## MEMORANDUM

**Subject:** 2nd Amendment to University Villages - Village 3 North and Portion of Village 3 Fire Protection Plan (2014)

**Date:** February 17, 2021

**Attachment (s):** Attachment 1 – Figures 2a and 2b – R-6, R-20, and R-19 Revised Land Use Maps  
Attachment 2 – Revised Figure 12 – Village 3 Fuel Modification Zones

Figures 2a and 2b – R-6, R-20, and R-19 Revised Land Use Maps

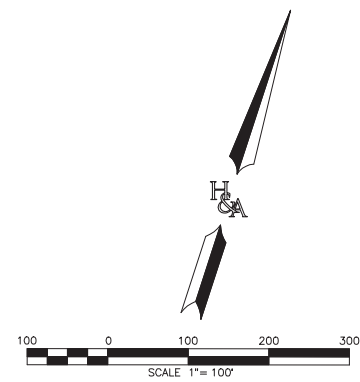
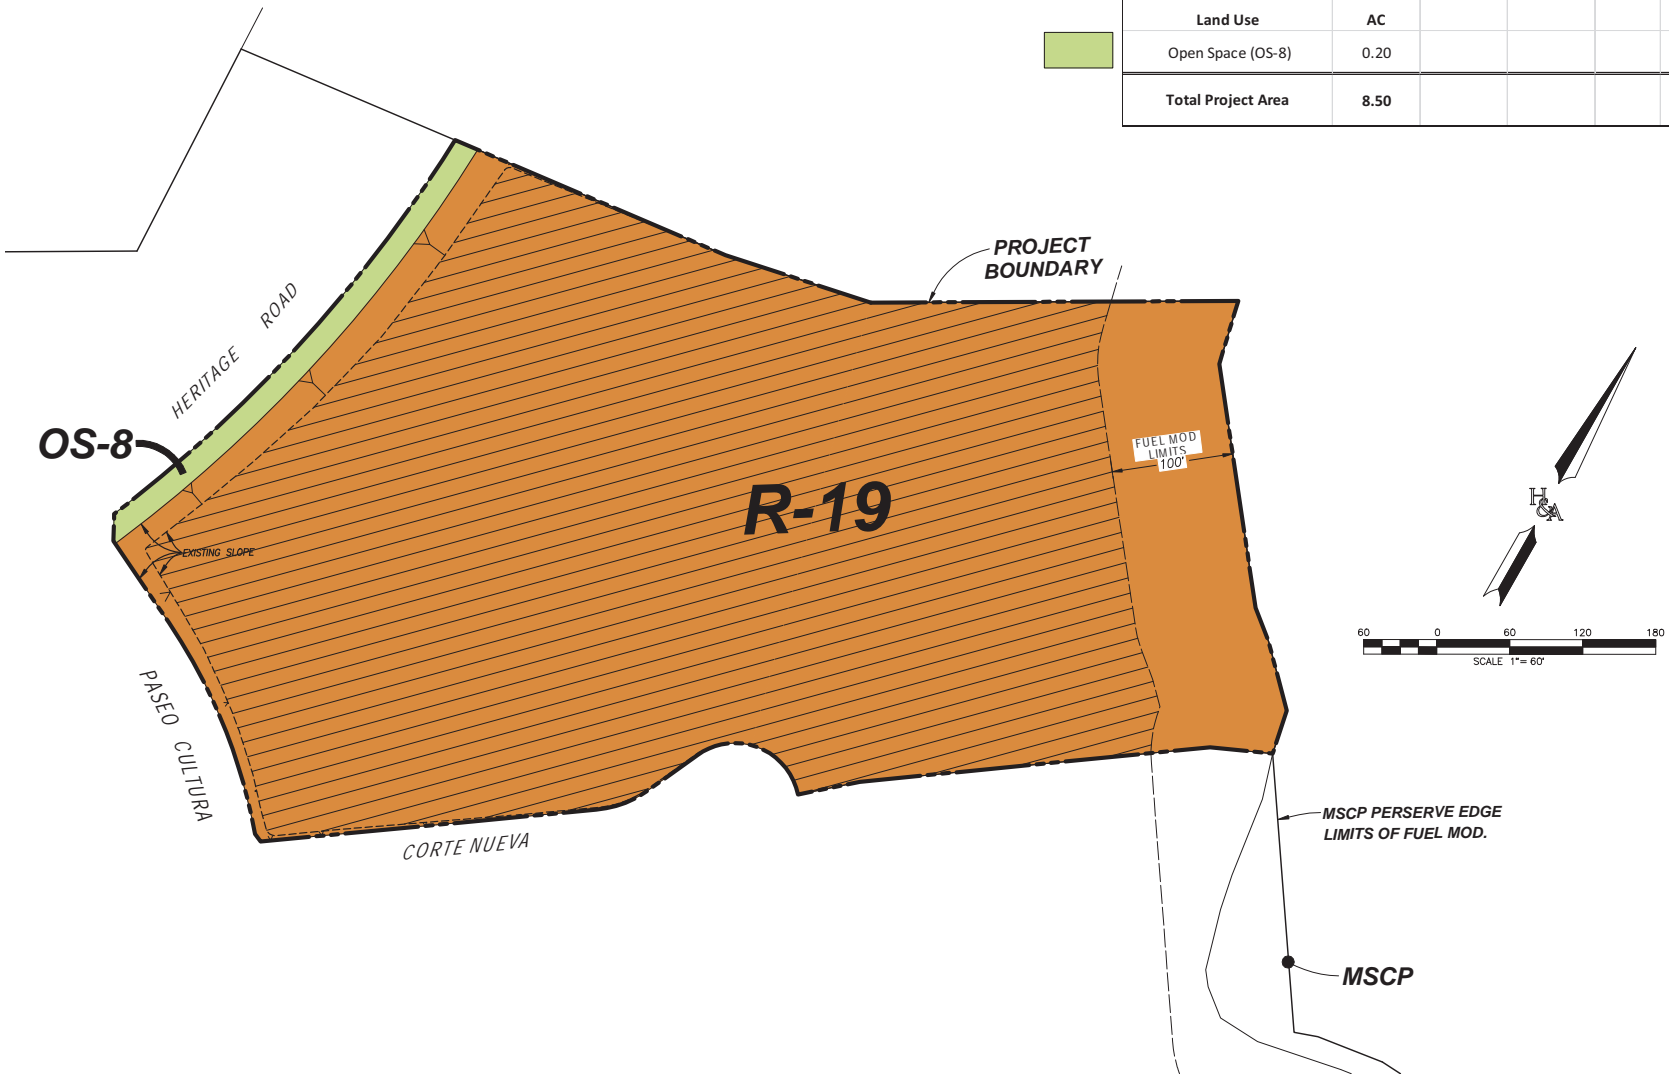
In May 2020, HomeFed Village III, LLC/FlatRock, LLC (Applicant) filed an application with the City of Chula Vista to amend the land uses within four parcels. The proposal would amend the two Village 3 North office parcels from Office to High Residential and the R-6 residential parcel from Medium Residential and Medium-High Residential. In addition, the proposal would incorporate a parcel located south of Main Street (FlatRock Parcel) into the Village 3 SPA boundary and amend the land use designation from Industrial to Medium-High Residential.

- Update the CVGP and GDP Land Use Maps and tables to change the land use designations for R-6 from Low-Medium Residential to Medium-High Residential; R-19 from Professional & Office to High Residential and R-20 from Limited Industrial to Medium-High Residential.

- Expand the SPA boundary to include the FlatRock Parcel which includes a parcel currently designated Limited Industrial and adjacent Open Space and Preserve Open Space areas.
- Change the land use designation and rezone a portion of the FlatRock Parcel from Industrial (I) to Residential (RM-1), designate the residential parcel “R-20” and allocate 116 multi-family units to R-20.
- Change the land use designation and rezone parcels O-1 and O-2 from Office (O) to Residential (RM-2), designate the parcel “R-19” and allocate 224 multi-family units to R-19.
- Change the land use designation and rezone parcel R-6 from Residential (SF-4) to Residential (RM-1) and allocate 78 multi-family units to R-6.

Updated Figure 12 – Village 3 North Fuel Modification Zones of  
Approved Village 3 North Fire Protection Plan

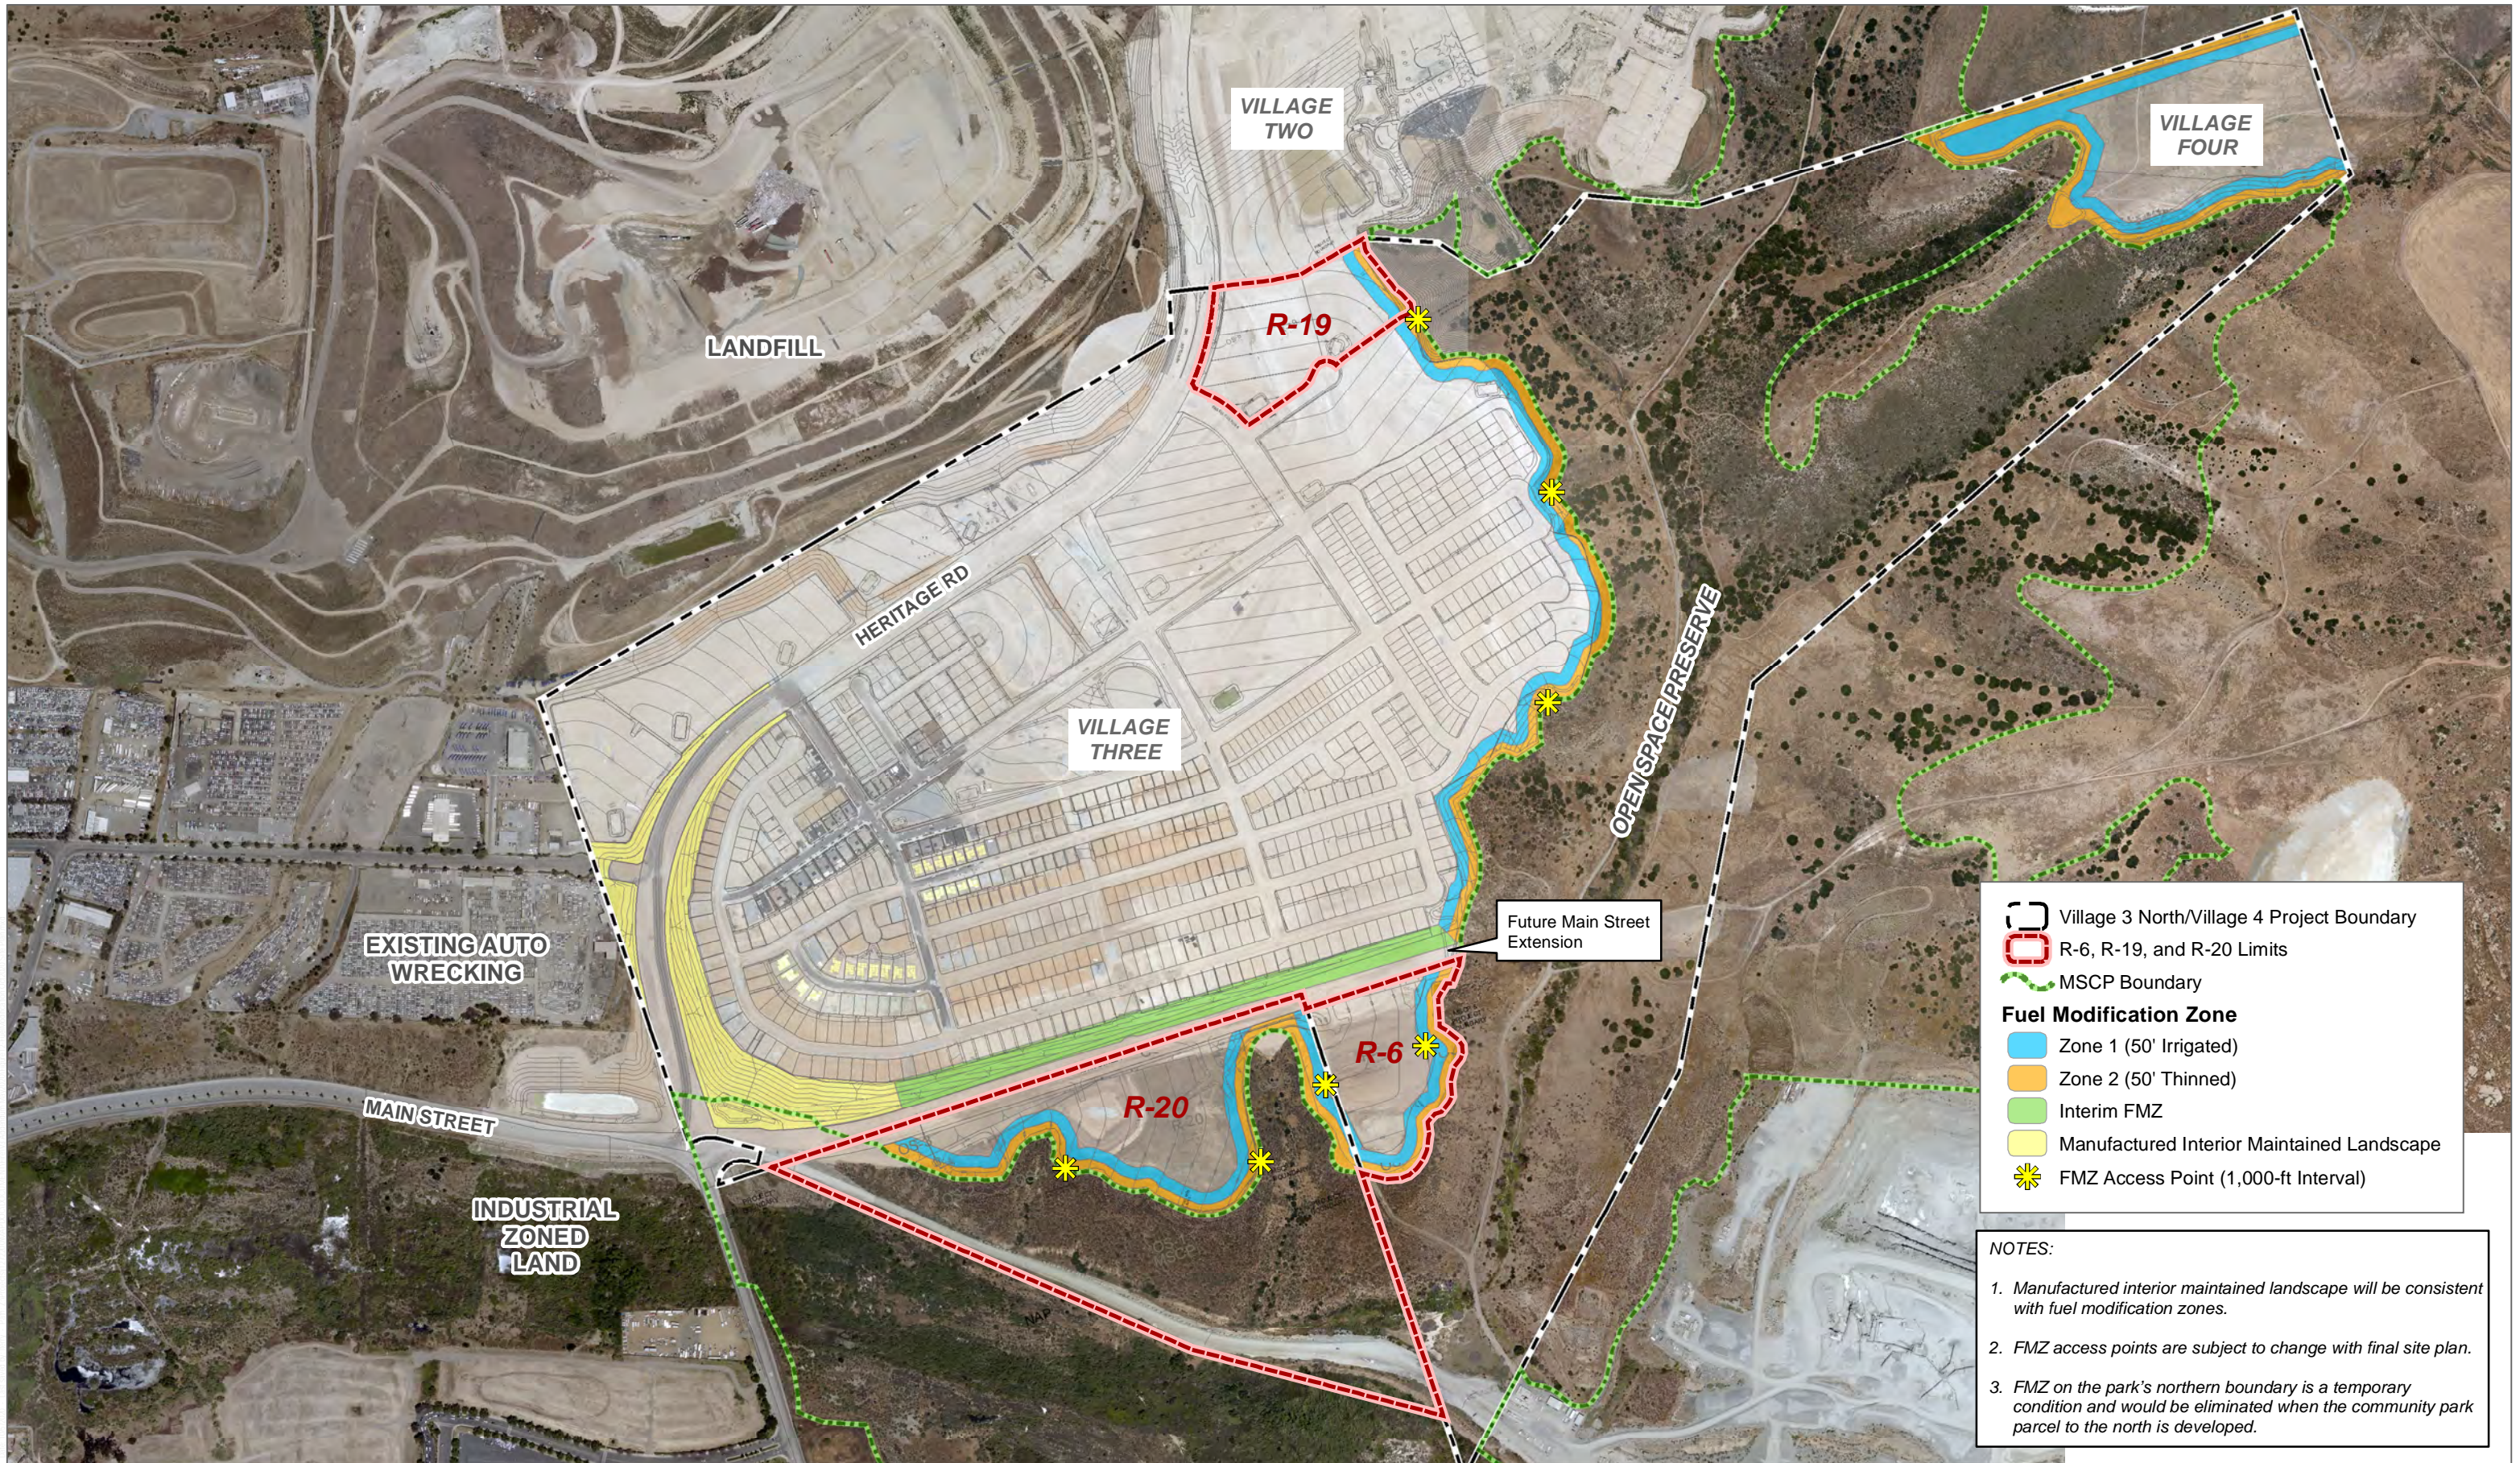
4. **Section 4.1.2 Other Vegetation Management** shall be amended to state the interface to the west of Village 3 is bisected by Heritage Road, which provides a 165-foot non-flammable boundary between residential structures and non-maintained fuels, including Manufactured Interior Maintained Landscaped slopes along Heritage Road and the Future Main Street extension, will be consistent with fuel modification zone guidelines. An interim FMZ shall be installed along the southern edge of the Village 3 core (north of the Future Main Street extension) until R-6 and R-20 development sites are completed. The interim FMZ shall be consistent with FMZ guidelines, including a 50-foot irrigated Zone 1 and a 50-foot thinned Zone 2. After completion of R-6 and R-20 development sites, the interim FMZ will be required to be maintained as Manufactured Interior Maintained Landscaped slopes consistent with the fuel modification zone requirements. Figure 12 – *Village 3 North Fuel Modification Zones Map* from the approved 2014 FPP has been updated and amends the FMZs.
